Memorandum

RE: **P.Z. 14-2020 84 Lumber (17519 Chesterfield Airport Road):**

An ordinance amendment to modify development criteria contained in City of Chesterfield Ordinance 2575 which established a “PC” Planned Commercial District on a 7.42-acre tract of land located at 17519 Chesterfield Airport Road (17U510073).

Planning Commission Staff Report

Figure 4b: Revised Arnage Access Exhibit

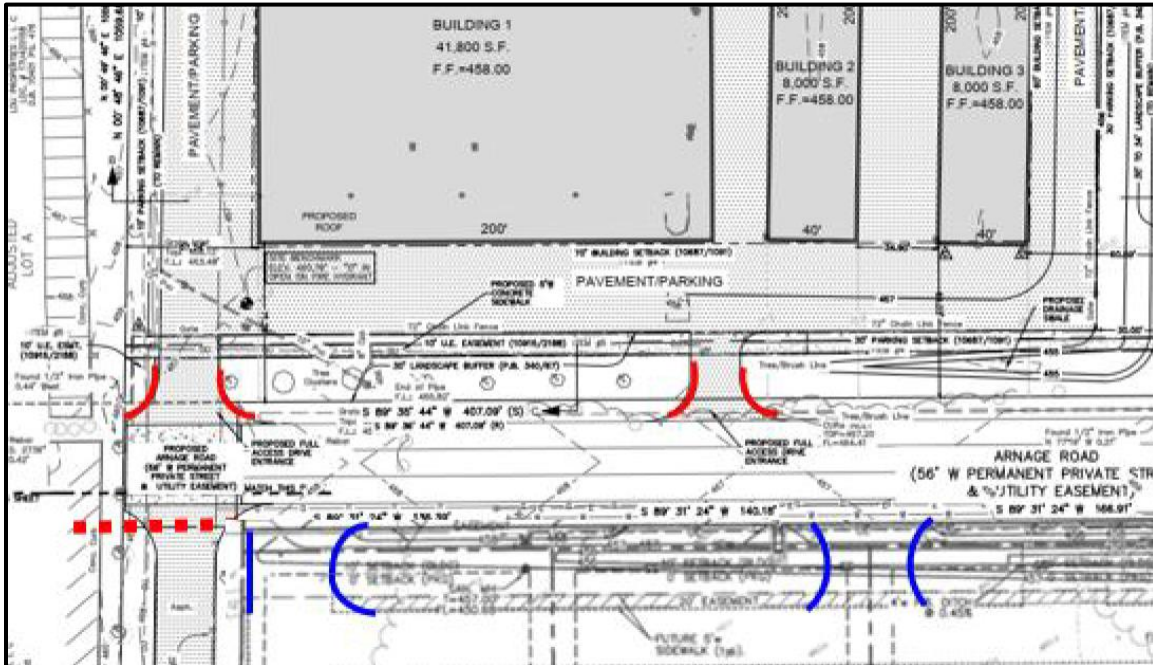
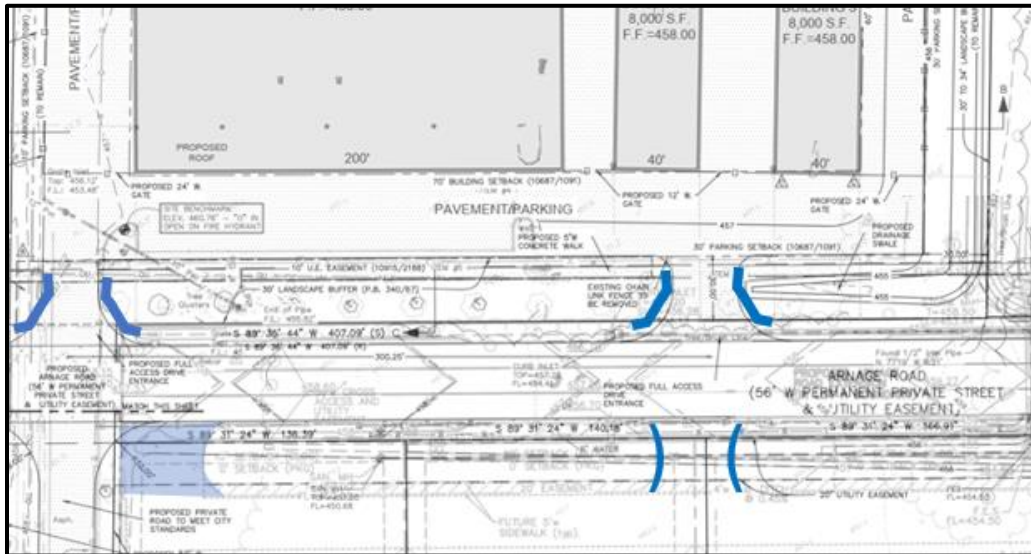
Issue #4—Access to Arnage Road

Issue: A Traffic Impact Study was included in the request to provide analysis on the impact of retaining access to Chesterfield Airport Road. An issue was raised regarding the Site Development Concept Plan for the TSG Chesterfield Airport Road subdivision directly south of Arnage Road. Staff instructed the applicant to provide detail on how the proposed access points to this site will comply with the UDC’s access management standards and avoid conflict with the proposed access points south of this development:

Applicant Response: The applicant has revised the Preliminary Development Plan to align the eastern access with the proposed access point to the development on the south side of Arnage Road and has confirmed that any proposed curb cut constructed by the

applicant will comply with access management standards. In addition, the applicant has provided a letter, furnished by the ownership of the development to the south, stating that it will modify its western curb cut to Arnage Road at the appropriate time to comply with access management standards if the access to Chesterfield Airport Road is retained and connected with Arnage Road. This access point is highlighted in blue in the figure below.
